Model: RMY-P2/MF2		Date: 18-Oct-16	No.: RM0A7001
Subject: Launch of the new model RMY-P2/MF2 (differences from the predecessor model)		Prepared by: Y.Miyamoto	
From: 1nd Tech Service Sect., MFP/Printer Tech Service Dept.			
Classification:	<input type="checkbox"/> Troubleshooting	<input type="checkbox"/> Part information	<input type="checkbox"/> Action required
	<input type="checkbox"/> Mechanical	<input type="checkbox"/> Electrical	<input type="checkbox"/> Service manual revision
	<input type="checkbox"/> Paper path	<input type="checkbox"/> Transmit/receive	<input type="checkbox"/> Retrofit information
	<input type="checkbox"/> Product Safety	<input checked="" type="checkbox"/> Other (New model)	<input checked="" type="checkbox"/> Tier 2

This bulletin announces the differences between the new model RMY-P2/MF2 and its predecessor model RMY-P1/MF1. As you are probably aware, an FSM exclusive for the new model will not be released. Please refer to the FSM of the predecessor model and this bulletin when servicing RMY-P2/MF2.

Subject: Launch of the new model RMY-P2/MF2 (P-to-P diagram)		Prepared by: Y.Miyamoto
From: 1nd Tech Service Sect., MFP/Printer Tech Service Dept.		
Classificat

Laser Unit (pg.39)

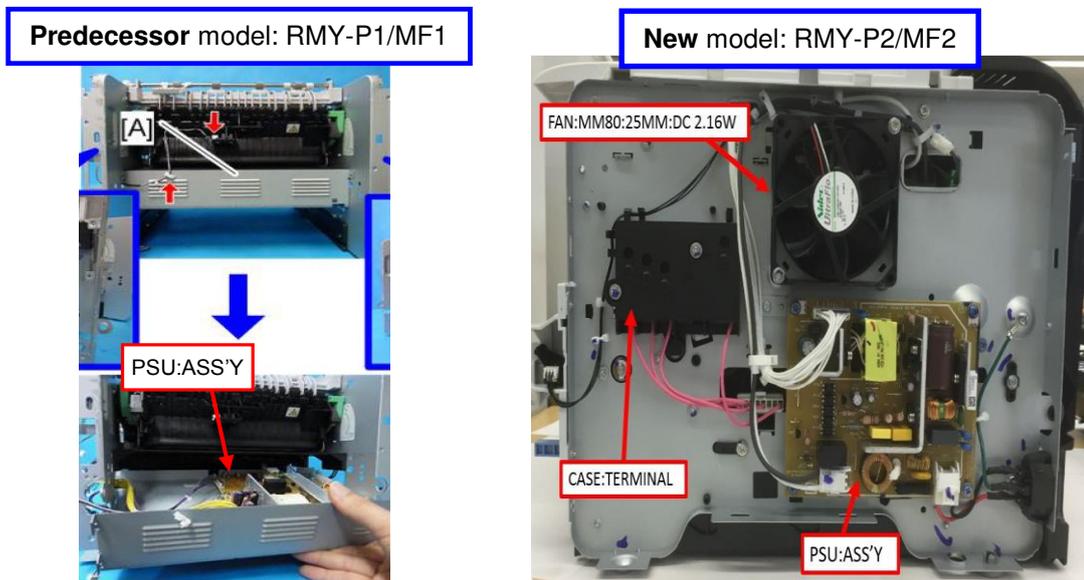
The laser caution decal was modified in line with the revised laser safety standard.

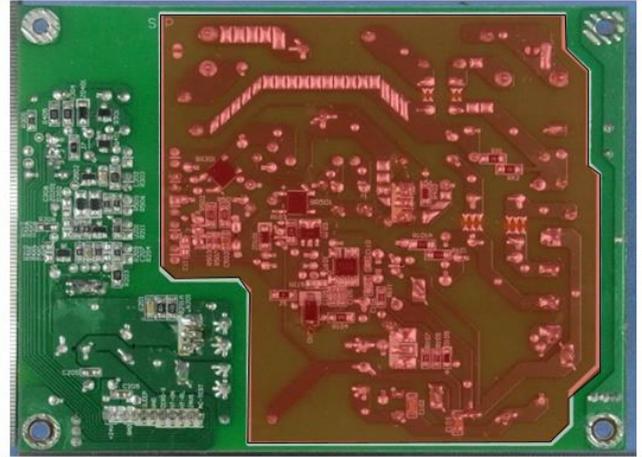
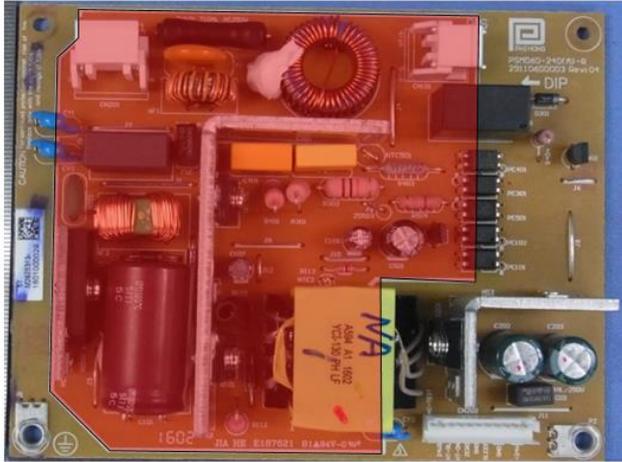
The replacement procedure of the PSU has changed due to the difference in the location of the PSU between the two models. In the predecessor model, the PSU is installed at the bottom of the machine, and in the new model it is in the right cover.

NEVER touch the areas outlined in red in the photos below to prevent electric shock caused by residual charge.

Residual charge of about 100V-400V remains on the PSU board for several months even when the board has been removed from the machine after turning off the machine power and unplugging the power cord.

RMY-P2:

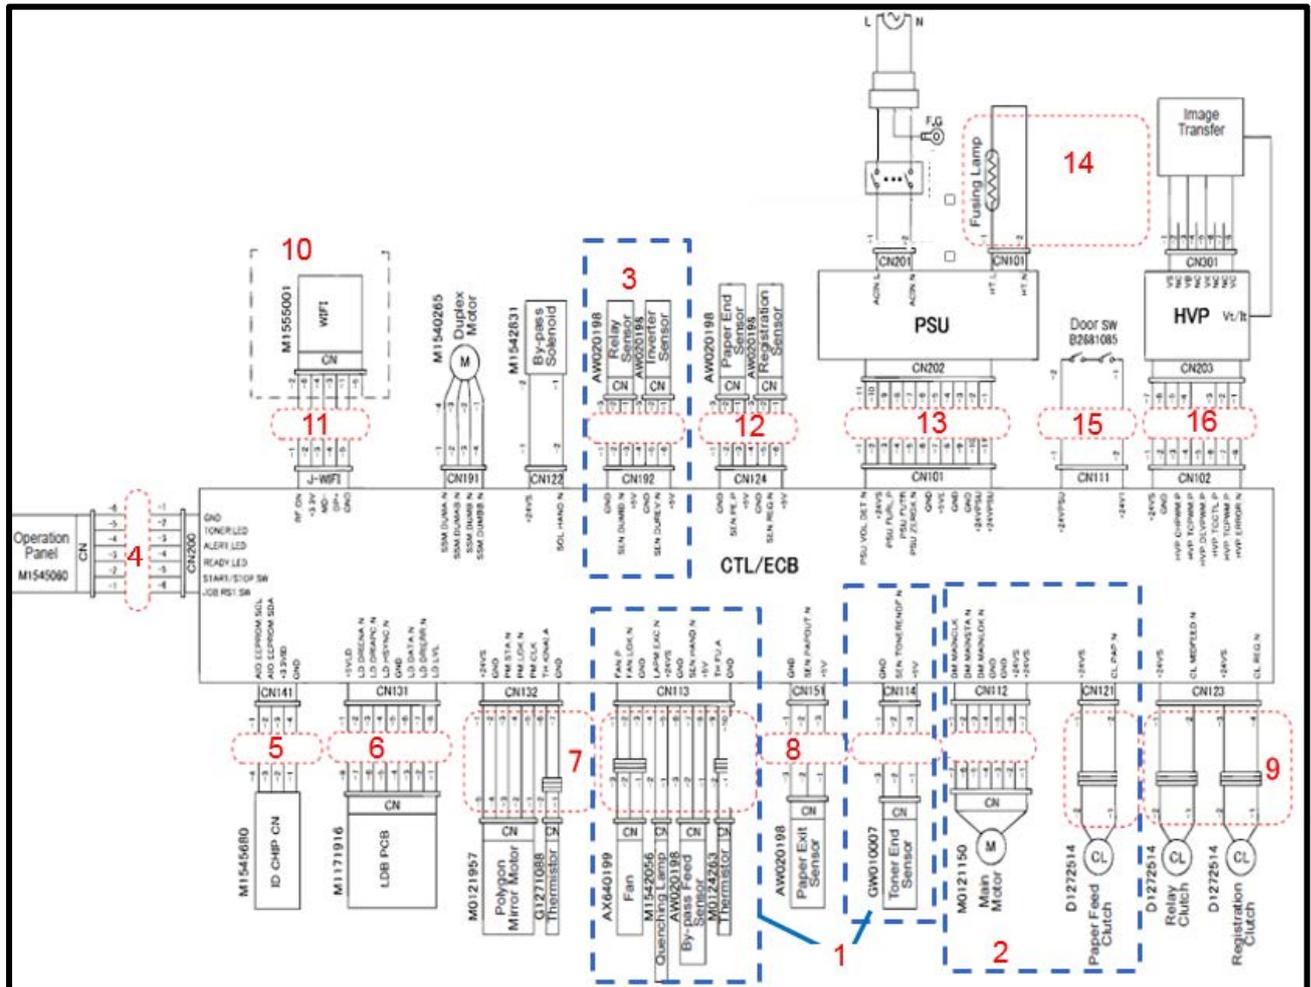
1. The toner end sensor is installed together with the fan, quenching lamp, by-pass feed sensor and thermistor (**#1**).
2. The main motor and paper feed clutch are combined (**#2**).
3. The relay sensor was deleted (**#3**).
4. Part numbers were changed (**#4 ~ #16**).

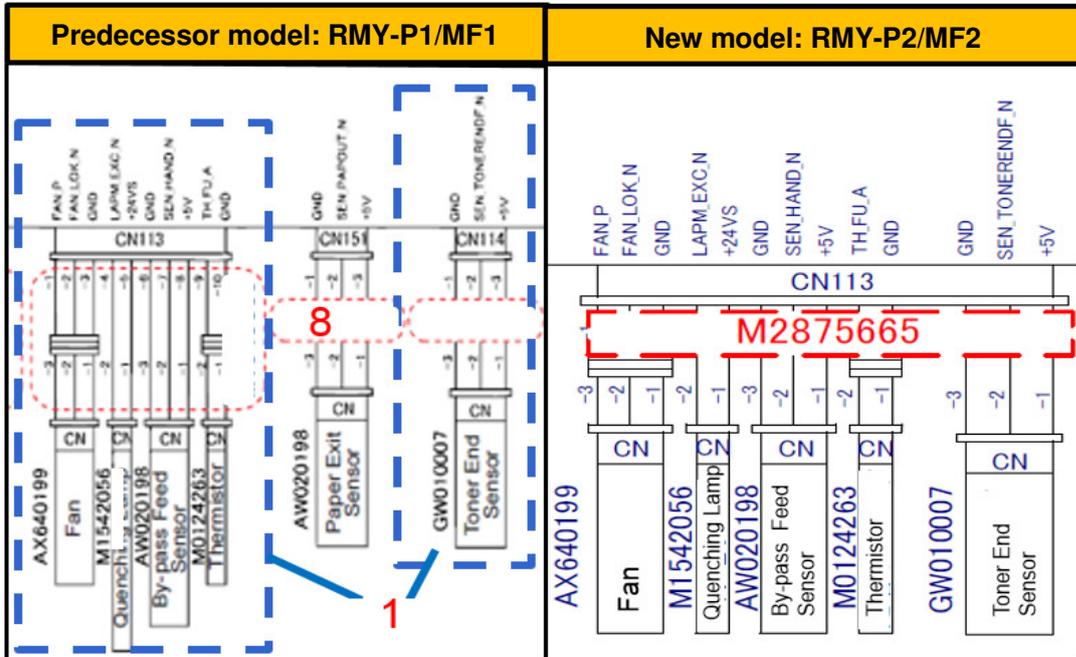
1. The toner end sensor is installed together with the fan, quenching lamp, by-pass feed sensor and thermistor (#1).

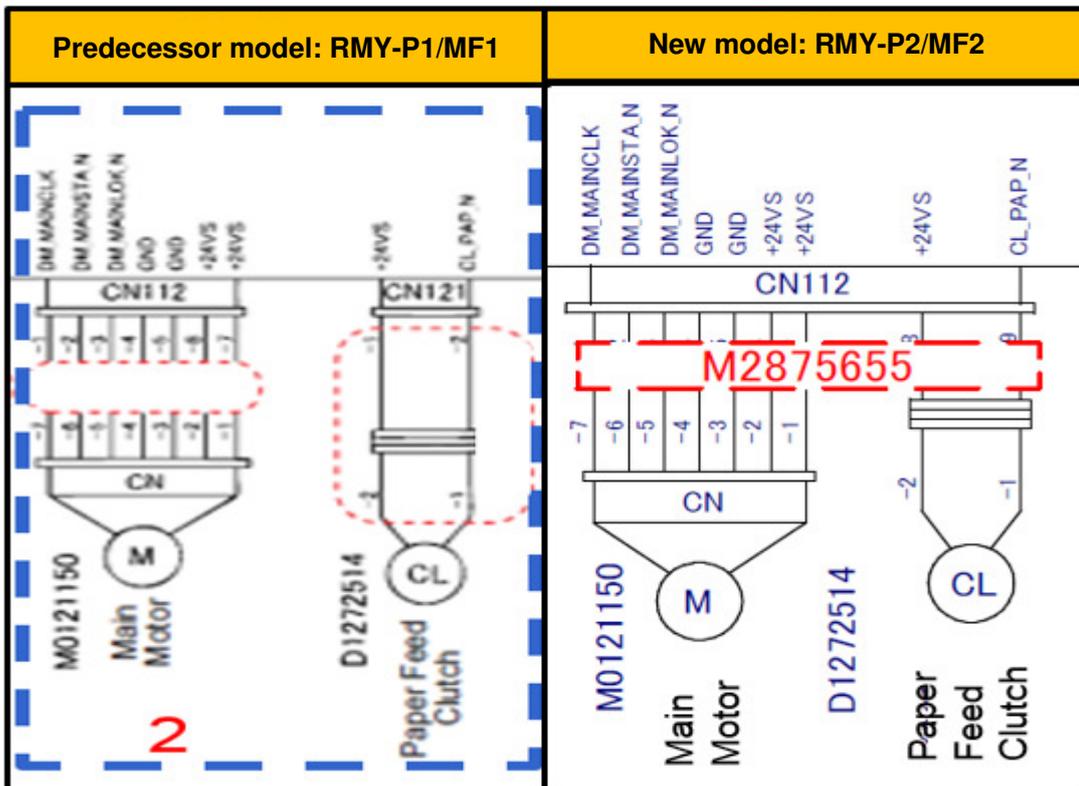
2. The main motor and paper feed clutch are combined (#2).

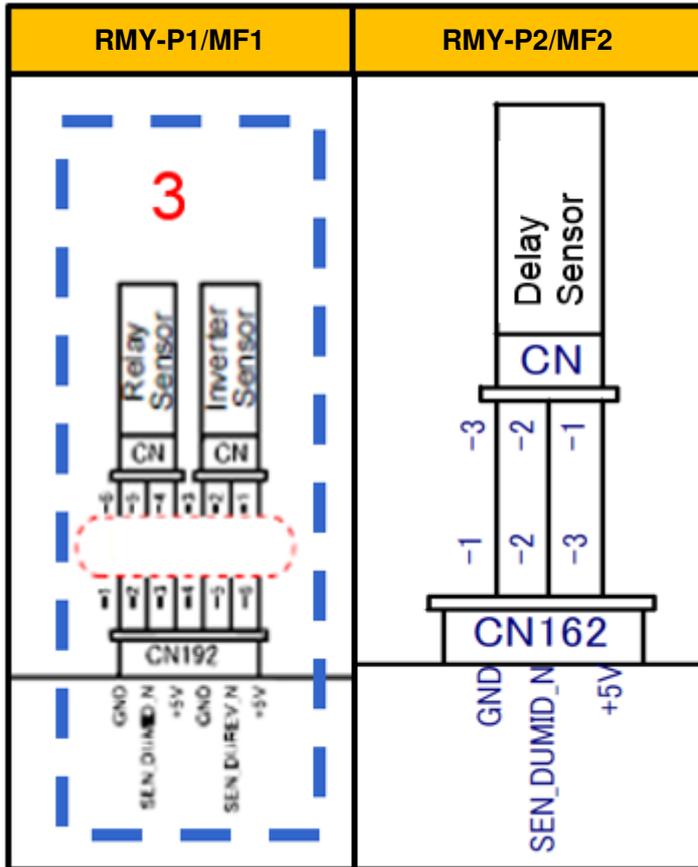
3. The relay sensor was deleted (#3).

4. The part numbers of the harnesses and the region codes were changed (#4 ~ #16).

Number	Item	New Parts Number
4	“Operation Panel” harness	<i>M2875005</i>
5	“ID CHIP CN” harness	<i>M2875680</i>
6	“LDB PCB” harness	<i>M2875654</i>
7	“Polygon Mirror Motor” and “Thermistor” harness	<i>M2871959</i>
8	“Paper Exit Sensor” harness	<i>M2875652</i>
9	“Relay Clutch” and “Registration Clutch” harness	<i>M2875666</i>
10	WIFI Board	<i>M287/M0BB</i>
11	“WIFI” harness	<i>M2875080</i>
12	“Paper End Sensor” and “Registration Sensor” harness	<i>M2875653</i>
13	PSU” harness	<i>M2875651</i>
14	Fusing Lamp	<i>NA : M2874220</i> <i>TWN : M2874229</i> <i>EU (CHN) : M2874221</i>
15	“Door SW” harness”	<i>M2875681</i>
16	“HVP” harness	<i>M2875670</i>

RMY-MF2:

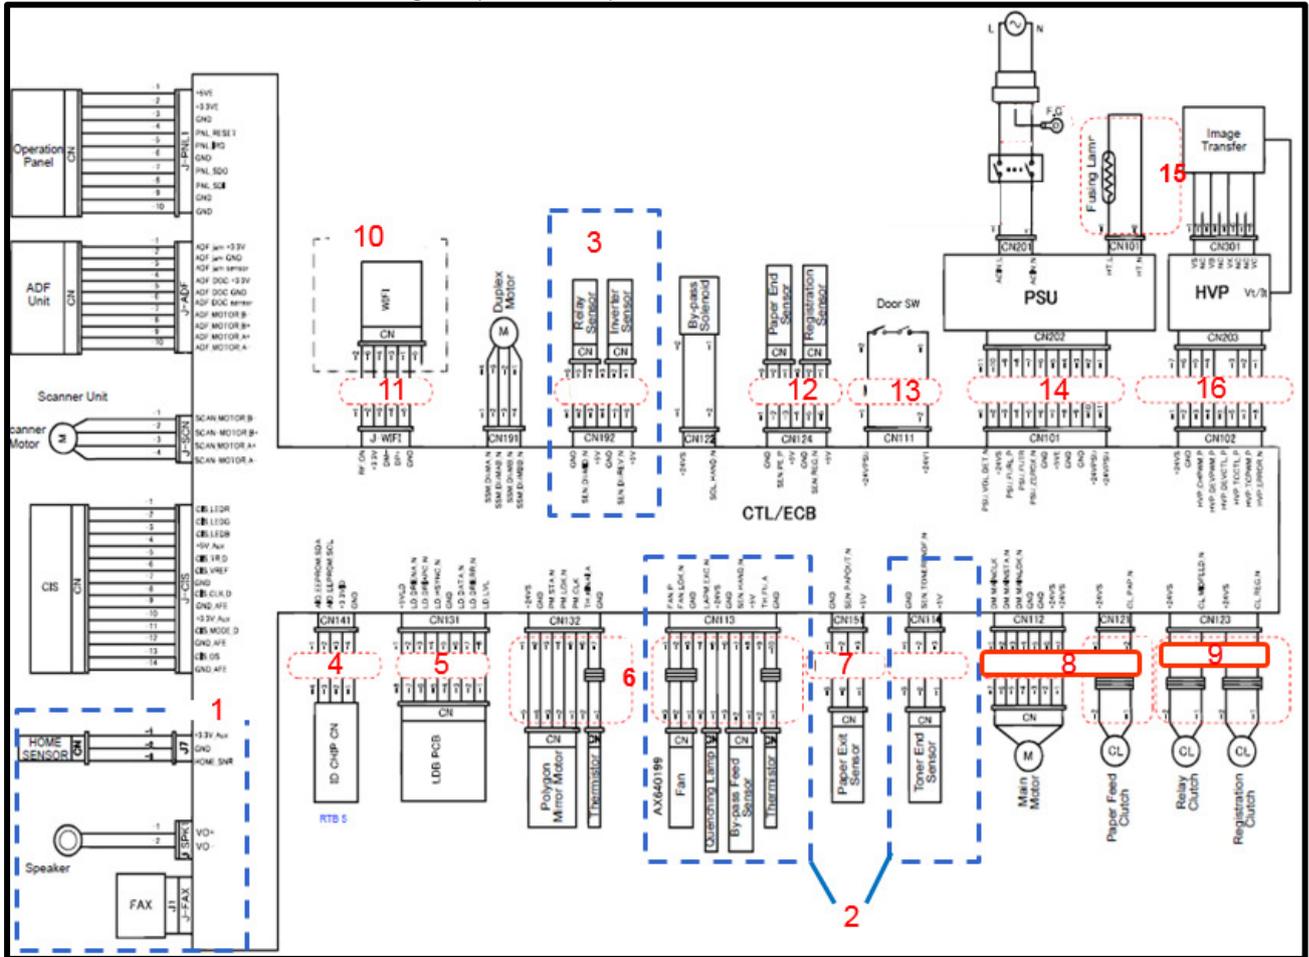
1. A USB is added (#1).
2. The toner end sensor is installed together with the fan, quenching lamp, by-pass feed sensor and thermistor (#2 in red).
3. The relay sensor was deleted (#3).
4. Part numbers were changed (#4 ~ #16).

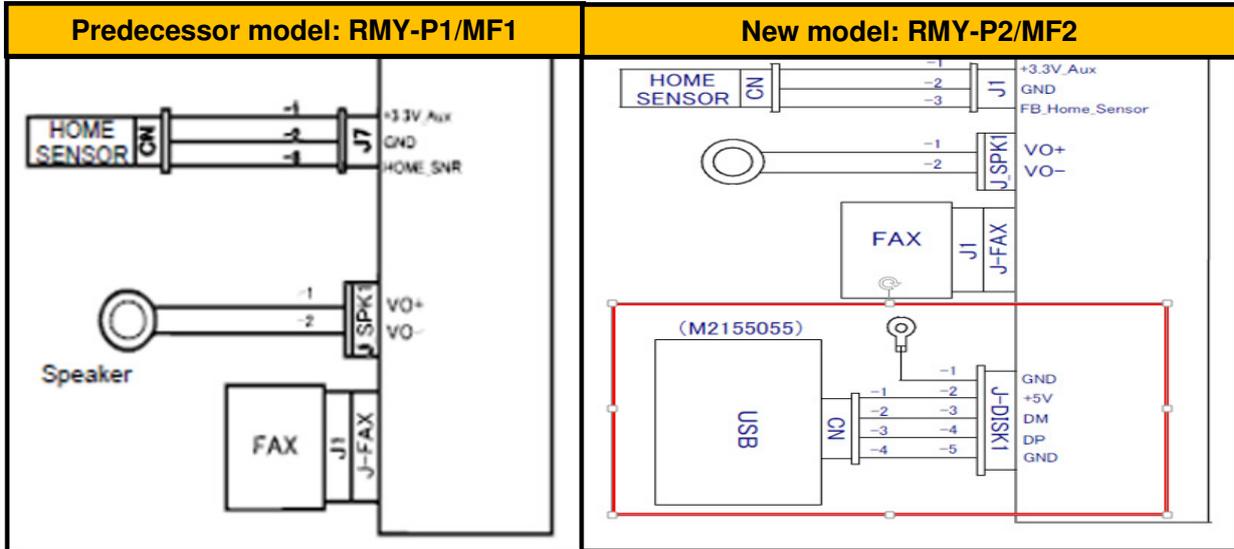
1. A USB is added (#1).

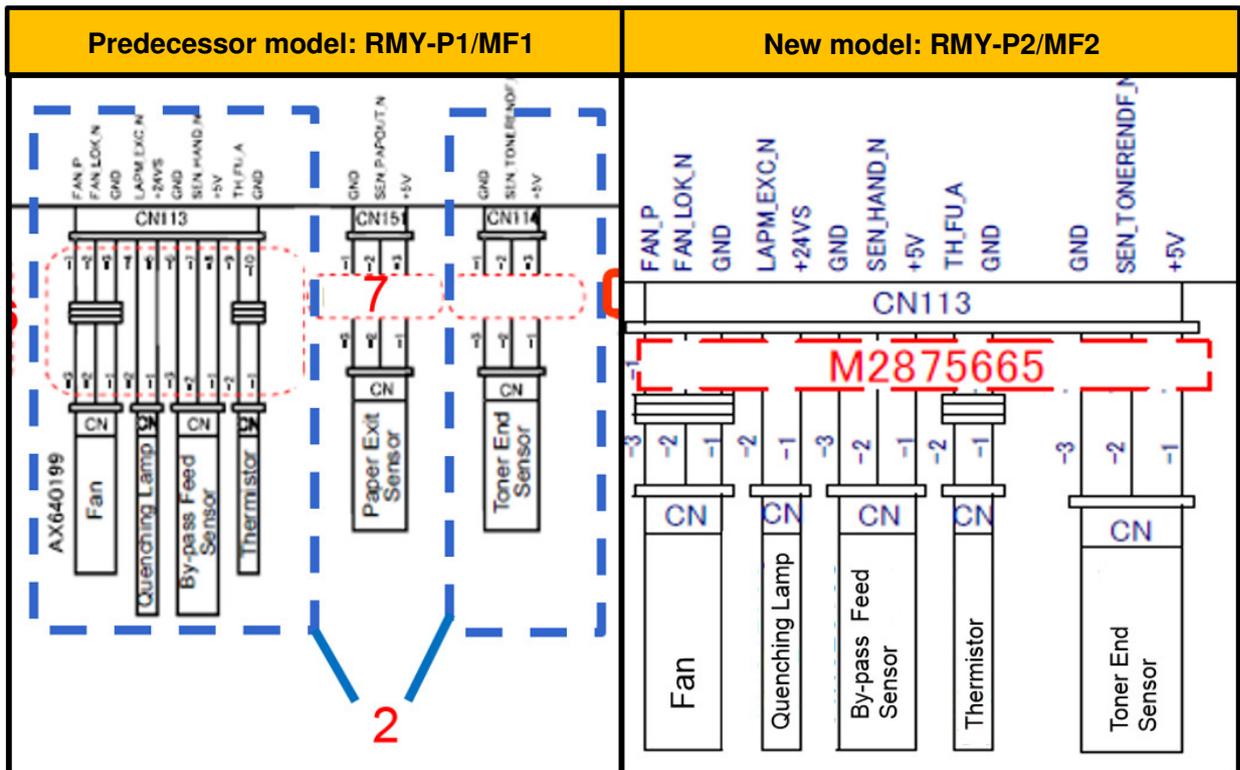
2. The toner end sensor is installed together with the fan, quenching lamp, by-pass feed sensor and thermistor (#2 in red).

3. The relay sensor was deleted (#3).

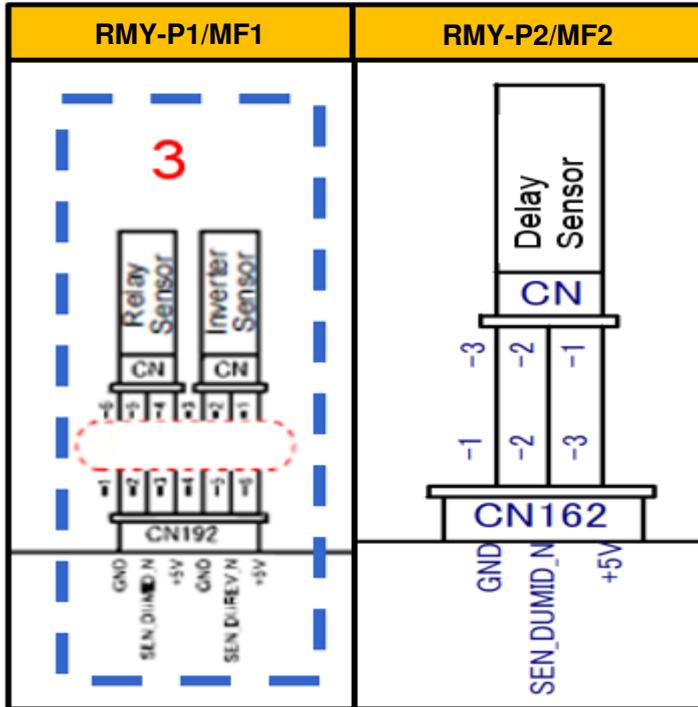
4. The part numbers of the harnesses and the region codes were changed (#4 ~ #16).

Number	Item	New Parts Number
4	"ID CHIP CN" harness	M2875680
5	"LDB PCB" harness	M2875654
6	"Polygon Mirror Motor" harness	M2871959
7	"Paper Exit Sensor" harness	M2875652
8	"Main Motor" and "Paper Feed Clutch" harness	M2875655
9	"Relay Clutch" and "Registration Clutch" harness	M2875666
10	WIFI Board	M288/M289/M0BC/M0BD
11	"WIFI" harness	M1555002
12	"Paper End Sensor" and "Registration Sensor" harness	M2875653
13	"Door SW" harness	M2875683
14	"PSU" harness	M2875651
15	Fusing Lamp	NA : M2874220 TWN : M2874229 EU (CHN) : M2874221
16	"HVP" harness	M2875670

4. Replacement and Adjustments > Electrical Components > When installing the new main board

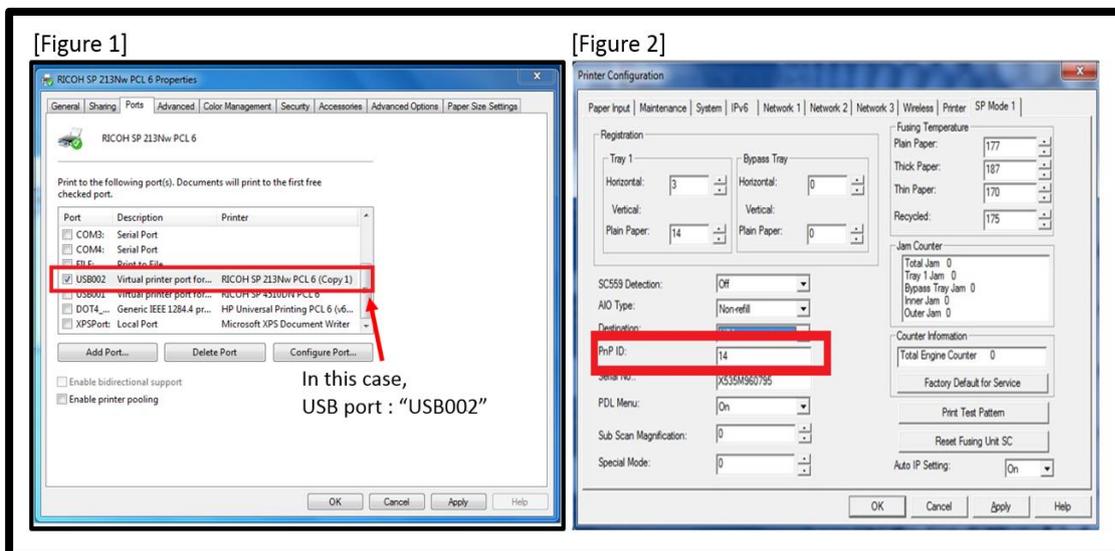
The procedure for replacing the Main Board was revised as follows.

- Install the printer driver and the SOM.
- Create a USB port for the printer. (Figure 1)
- Verify the PnP ID of the printer. (Figure 2)

1. Replace the main board.
2. Turn ON the device.

3. Connect SOM to the device with a USB cable.
4. Verify that the port is identical to that created in the preparation step (Figure 1). If not, correct the port.
5. Type in the PnP ID verified in the preparation step (Figure 2).
6. Set the destination code according to the following table.
